AGENDA
COMMITTEE OF THE WHOLE
July 24, 2018
2200 Harnish Drive
Village Board Room
- AGENDA -
7:30 P.M.

- D. Consider a Request for Re-Zoning, Final Plat, Final PUD and Special Use Permit for 2401 Huntington Drive North Case No. 2018-09. CarMax Auto Superstore

FROM: Benjamin A. Mason, AICP, Senior Planner

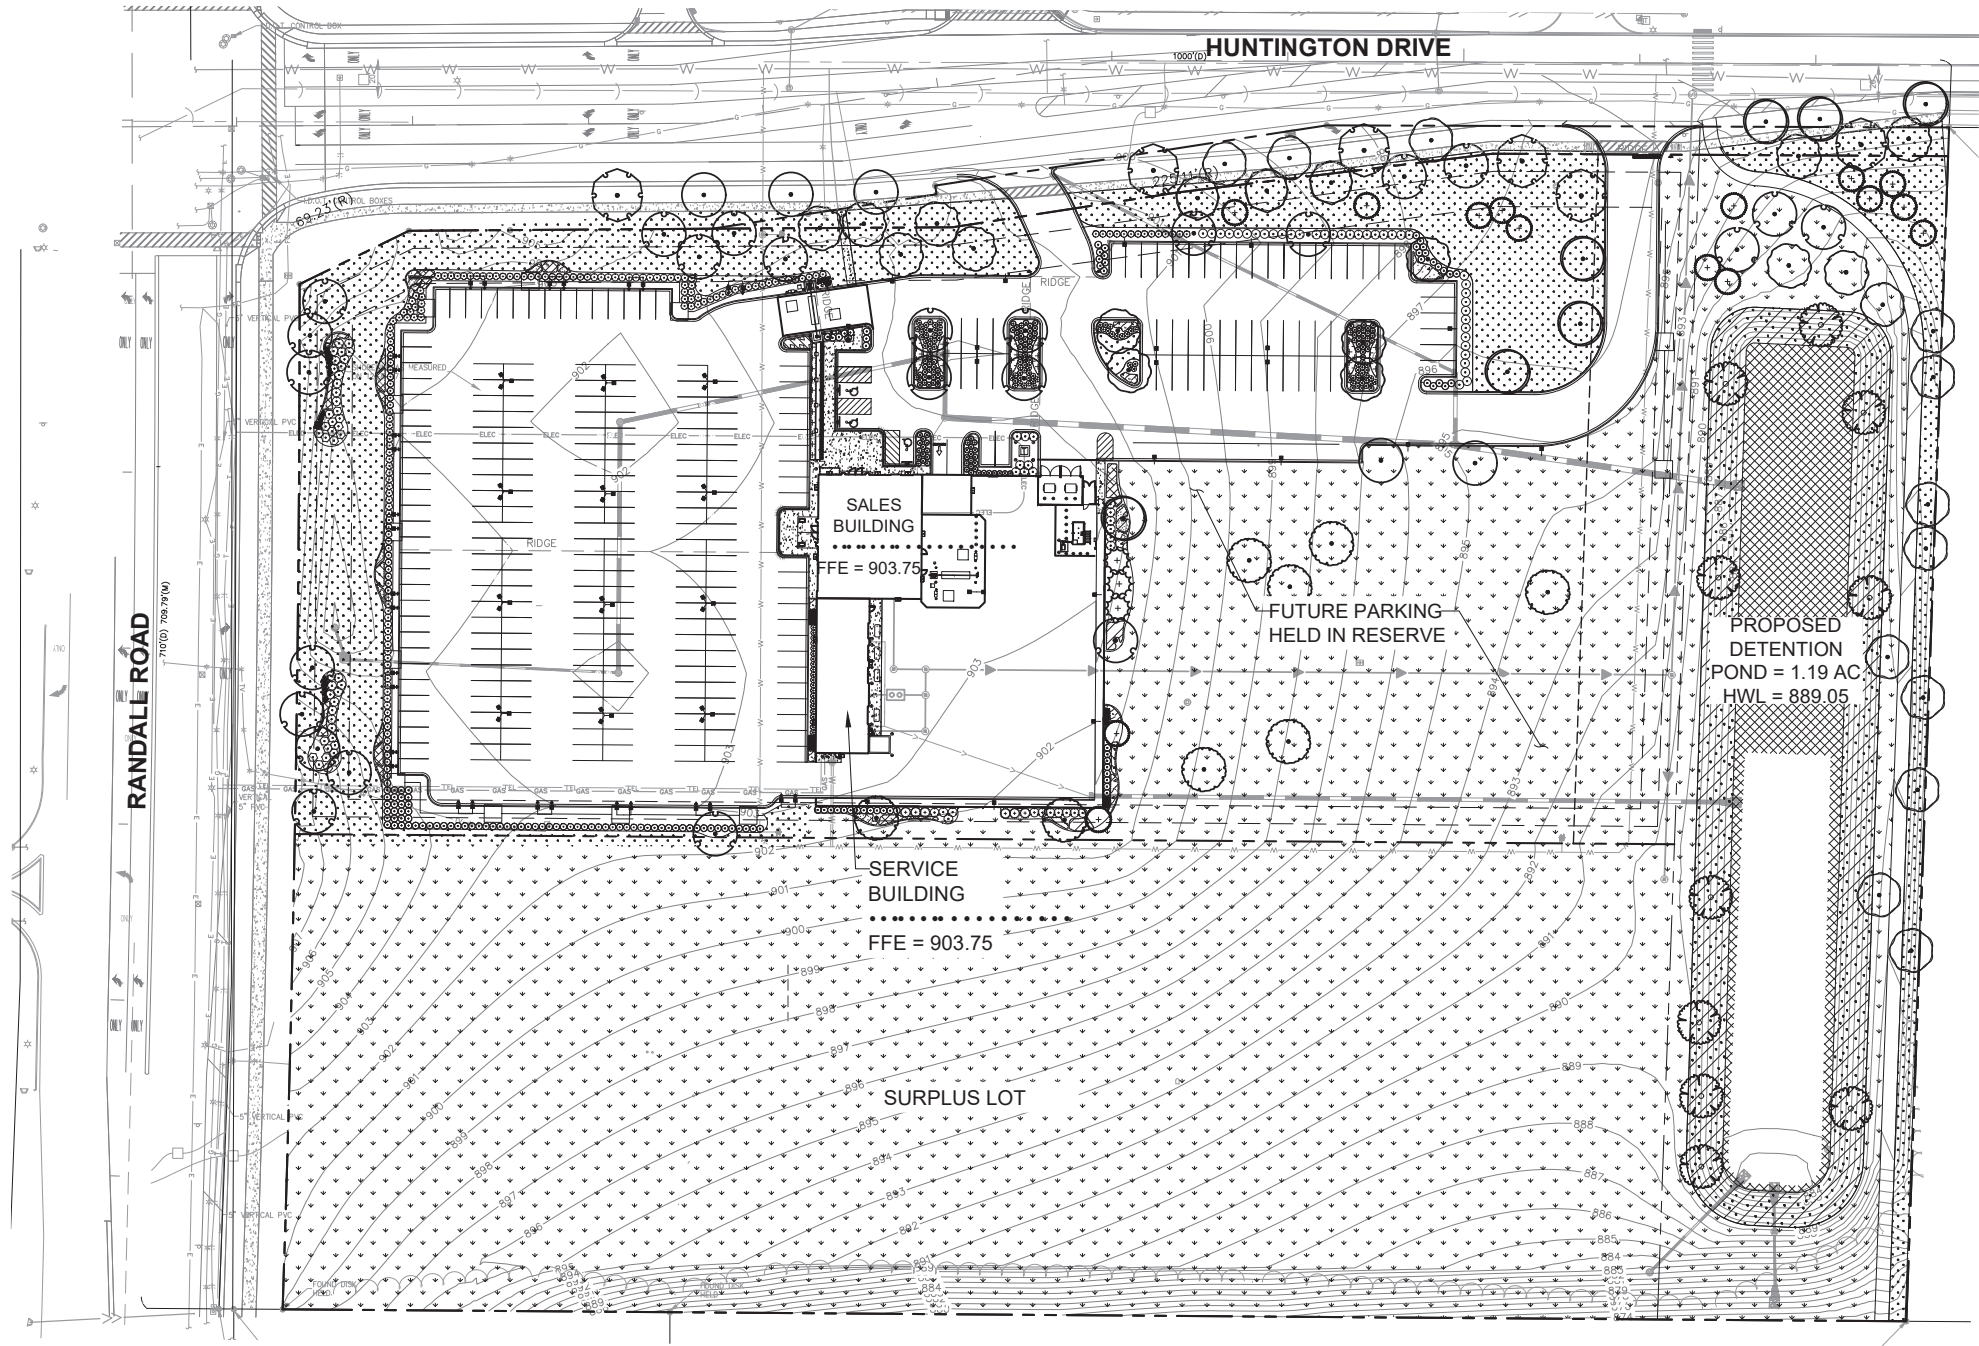
- Landscape Plan
 - Approximately 40 percent more trees have been added to the enclosed / revised plans, in particular at the northeast corner of the property along Huntington Drive. The landscaping along Randall Road has also been enhanced to include some landscape beds and more formalized grouping of trees to better frame the western side of property, as opposed to the more random placement of trees along Randall Road that were depicted on an earlier version of the Landscape Plan.

- Plant selection is good, with nice variety of trees and shrubs.
- Plant schedule:
 - A dry-bottom detention mix, which appears to be proposed on the side slopes of the detention area, is noted in the schedule. Mix details should be provided to verify appropriate species.
 - Plugs are noted for planting in the north end of the pond. The type of plugs (species, size, spacing) should be provided.
 - Planting size should be specified (3" caliper trees, shrub size, etc.)
- Planting for the south end of the detention should be specified.

7. The Landscape Plans as prepared by Kimley Horn with a latest revision date of June 21, 2018 shall be revised to incorporate comments from the July 3, 2018 Christopher Burke memo, the July 10, 2018 Public Works memo, and the July 6, 2018 Teska Associates memo. The area designated as Future Parking Held in Reserve shall include perimeter landscaping of shrubs and perennials, similar to elsewhere on site, if and when that area is developed for additional parking.

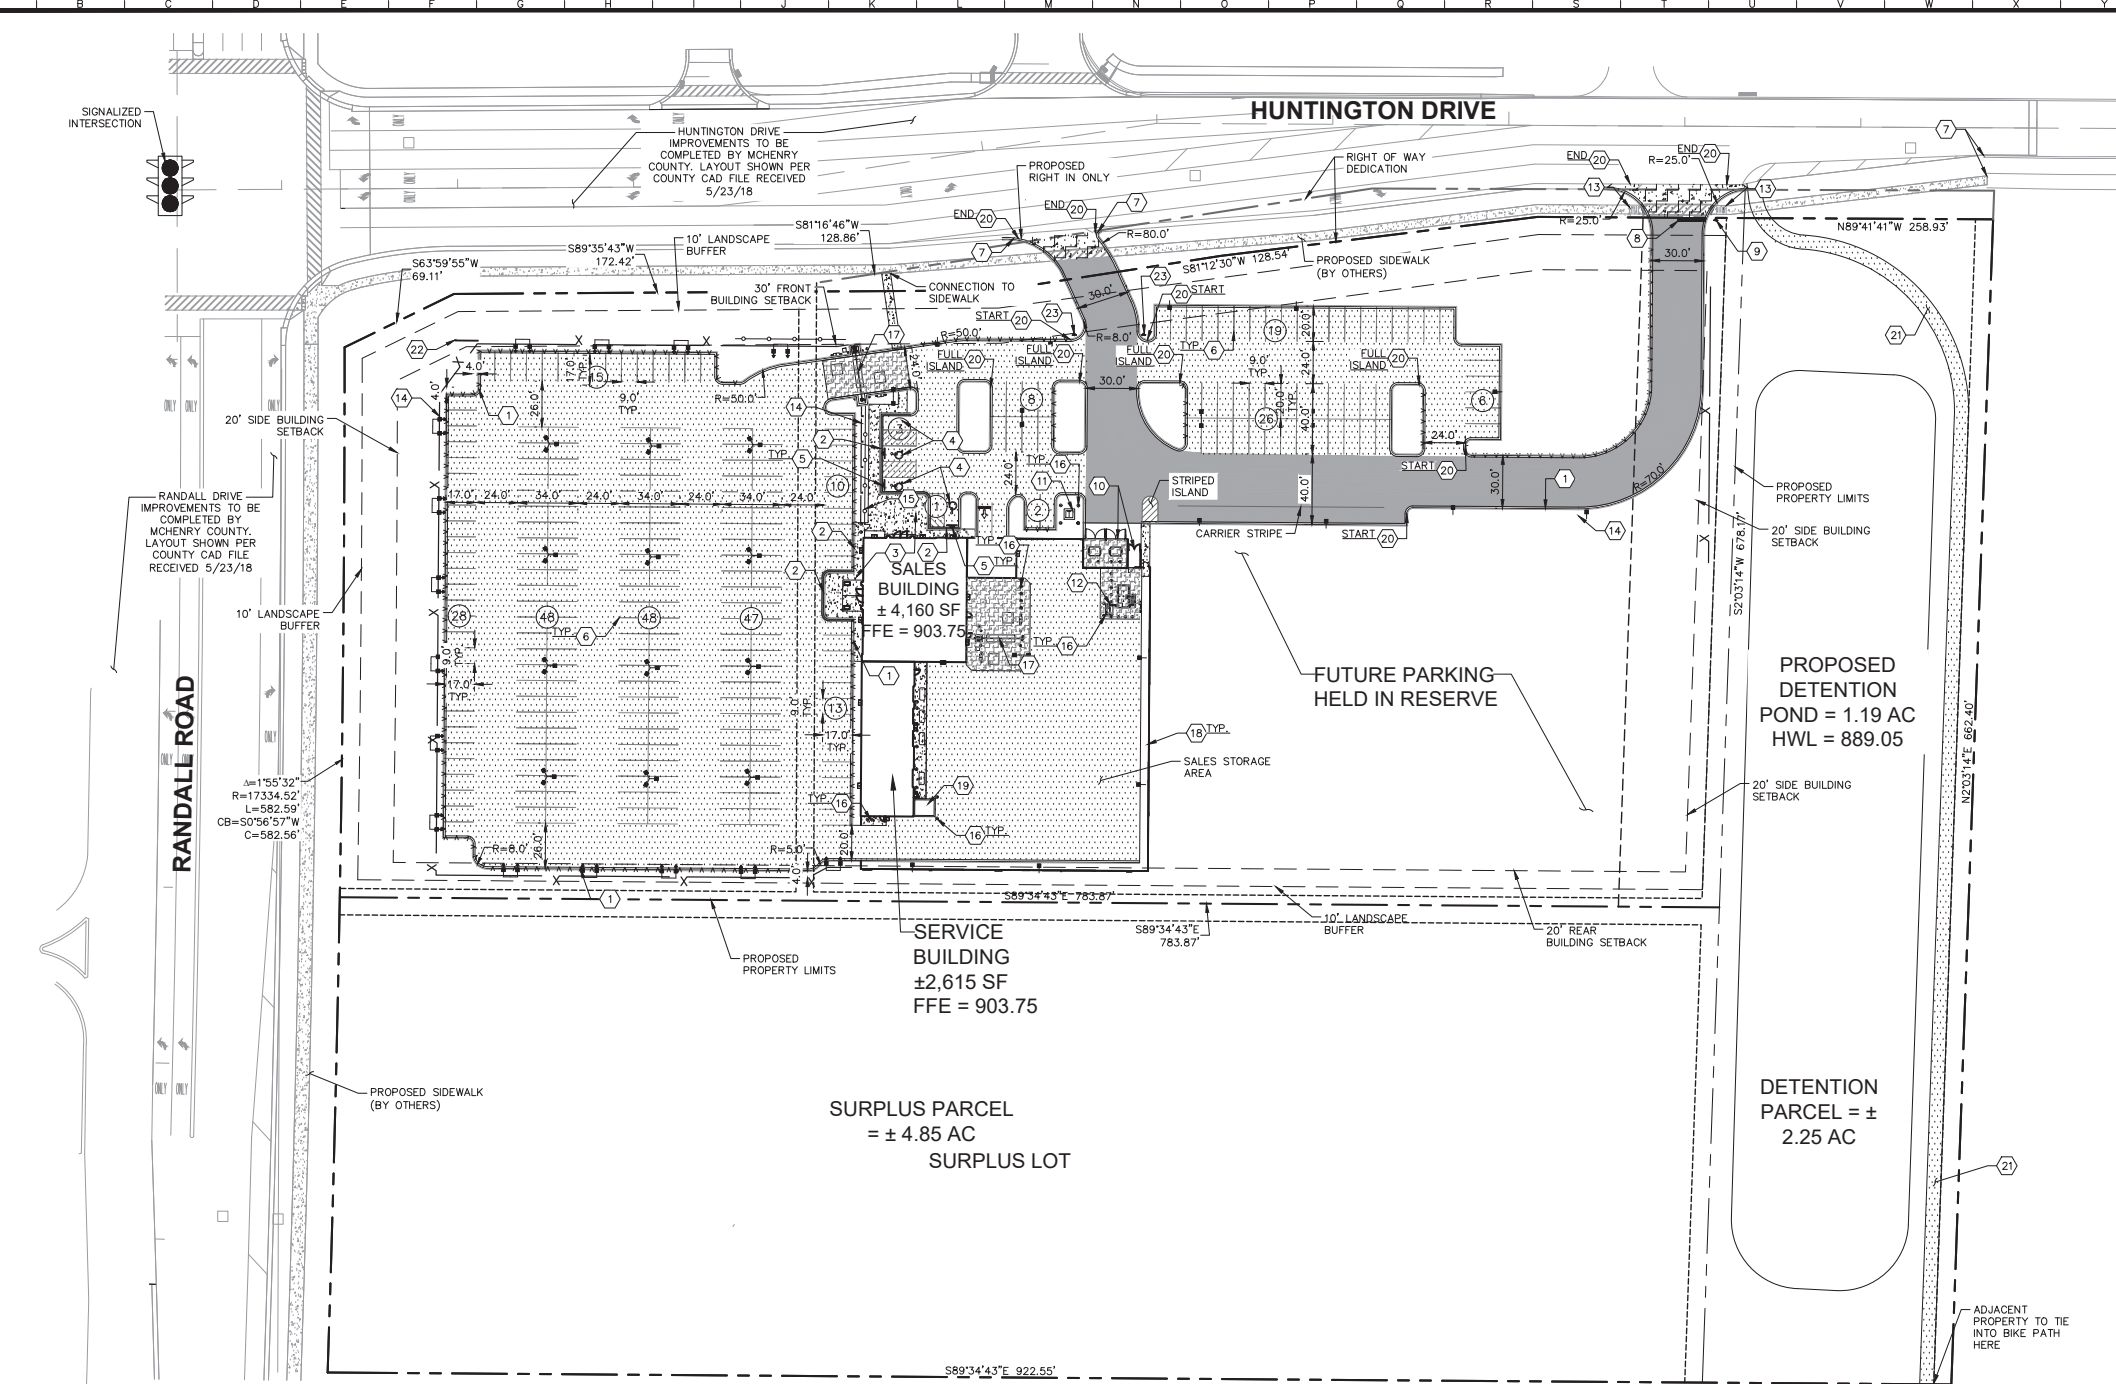
Sheet C1.0

1. The striping for the full (east) access driveway is missing from the plan sheet; one inbound land, one outbound left turn lane, one outbound shared thru and right turn lane. It appears from the engineer's response that he misinterpreted this previous comment.

2. Sidewalk crossing striping should be added across the driveway where the connecting sidewalk from Huntington Drive intersects with the internal driveway. It appears from the engineer's response that he misinterpreted this previous comment. We are referring to an on-site location adjacent to the pop-up security gate separating the outside vehicle storage from the customer parking area.

3. The section of newly added mountable curbing along the south side of drive aisle (adjacent to the carrier stripe) should be revised to a barrier curb & gutter section to provide more positive drainage to the inlet structure to the east.

C1.0	Plans shall ensure proper alignment of bike path crossing of Huntington Drive. This path will also be crossing a collector roadway midblock without stop control, as such a rapid round flashing beacon assembly shall be installed
C2.0	There is a swale indicated along the south property line, however the grading plan does not reflect the depth nor is there a cross section depiction of this swale. In addition, the spot grades shown in the swale do not make sense
C3.0	List the structure sizes and frame types for each installation. Follow Village iron requirements for all Village owned assets
C3.0	Provide unique identifiers for each structure, including hydrants
C3.0	The proposed water loop is in an appropriate location however the valve locations are still not appropriate.
C3.0	Please note that sanitary services shall wye into the Village main
C3.0	It is necessary to provide profile sheets for Village water and sanitary mainline installations

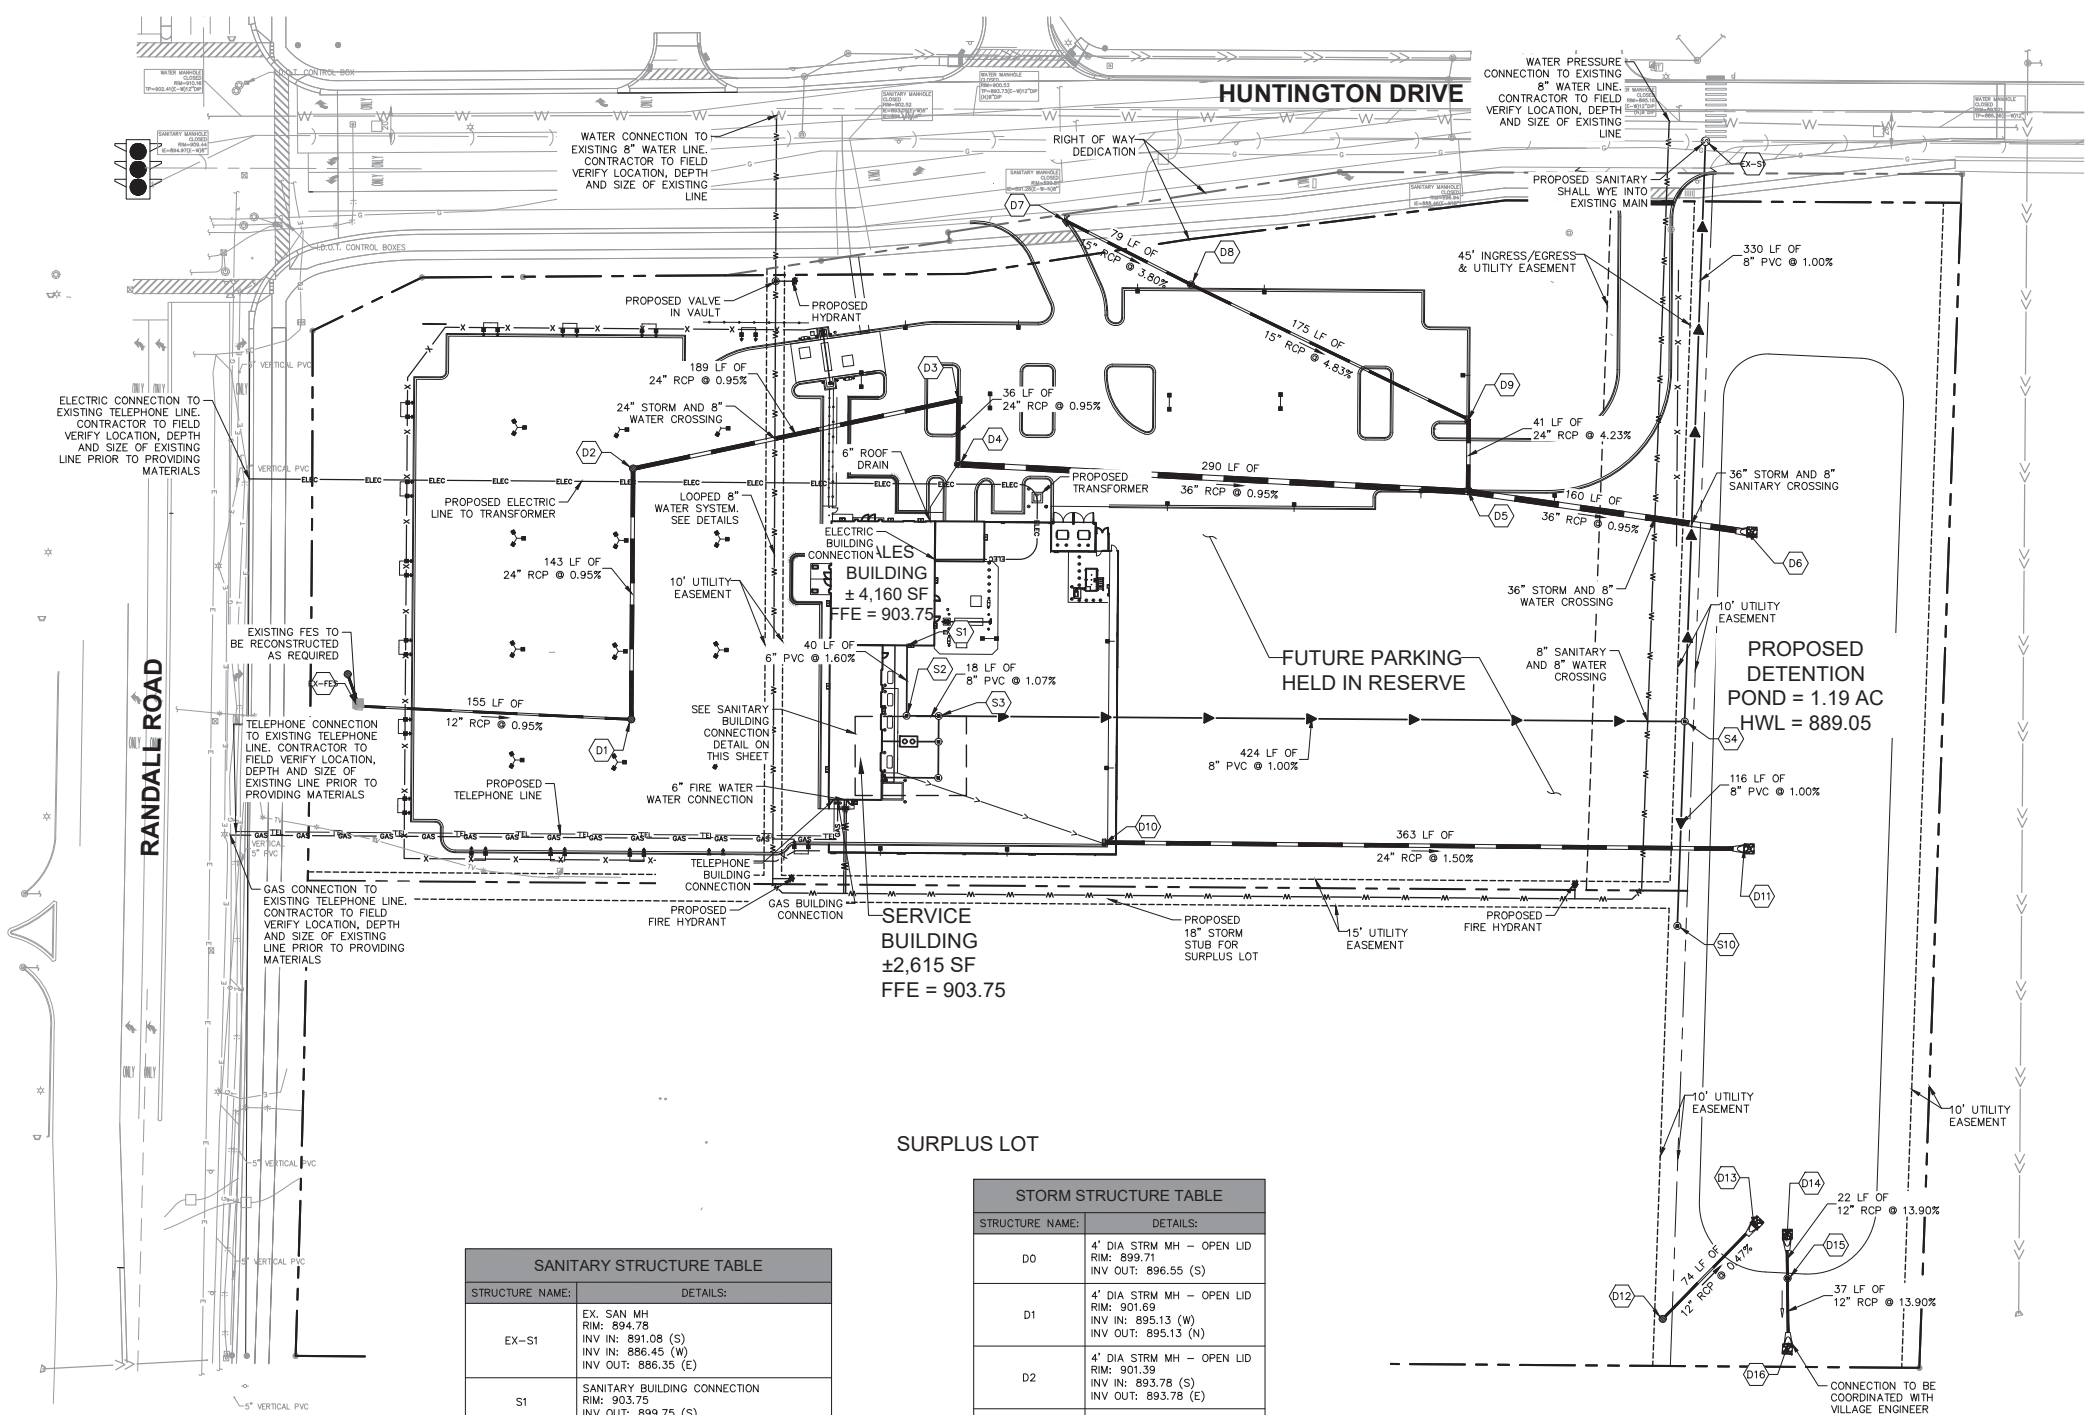
38. The boundaries of the proposed utility easements shall be revised so that the proposed fire hydrants are encompassed by the easements (typical to Plat and Preliminary Engineering plan sheet C3.0).
39. Revise the label of "Hereby dedicated to the Village of Algonquin" to "Hereby dedicated to the Village of Algonquin for Roadway & Utility purposes" on sheet 1.
40. Revise the label of "(Detention Area)" on Lot 3 to "(Detention Area and Drainage Easement)" unless the lot is to be turned over to the Village for ownership and maintenance.
41. Drainage\Detention Easement Provisions for Lot 3 should be added to sheet 2 if the lot will not be turned over to the Village for ownership and maintenance.

C3.0	Create a conflict chart for all utilities that cross each other. For example if a sanitary sewer crosses under a watermain, the top of the sanitary main shall be listed and the bottom of the watermain shall be listed. If a conflict occurs a correction shall be listed (ie lower watermain, install water quality casing, etc...)
L1.0	The Village has reviewed the tree removal plan and calculated that the reforestation fee is currently \$263,450.00. Per code the removal dbh is calculated at 2814.5 inches, while the site calls out for 180 inches of replacement. A 2,634.5 dbh difference @ \$100 per dbh = \$263,450.00.
L1.0	List plant sizes for trees (caliper), shrubs (gal) and perennial (gal)
